Pūroro Āmua | Planning and Environment Committee

Questions and Answers

10 November 2021

2.1 The Parade Upgrade - Design Options

Figure 2.1: Bent-in cycleway layout¹

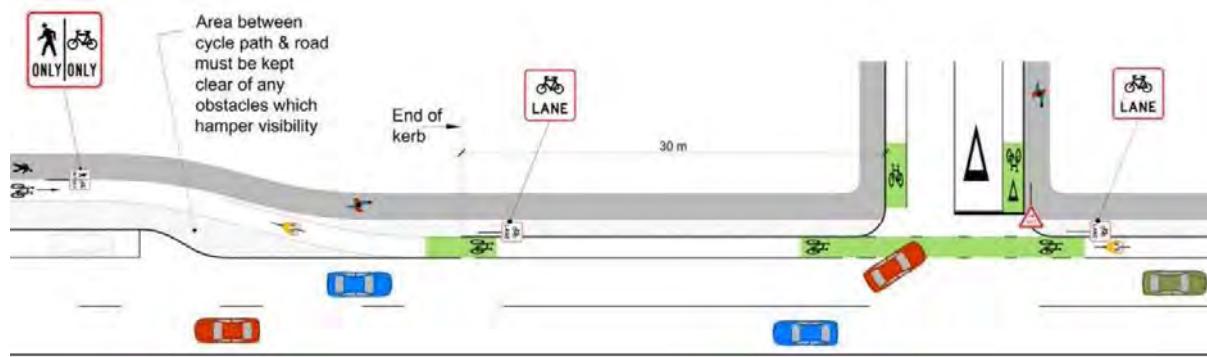
Will the intersections still divert cyclists out into the road in order to have priority over turning traffic to go straight through the intersection?

For the Safety Improvements option, a “bent-in” intersection approach is proposed for the intersections. An example of this approach is shown in Figure 2.1. This treatment would provide clarity that cyclists have priority across the side streets. This treatment would also make cyclists more visible to drivers at the intersection and make it easier to anticipate the cyclists’ movements.
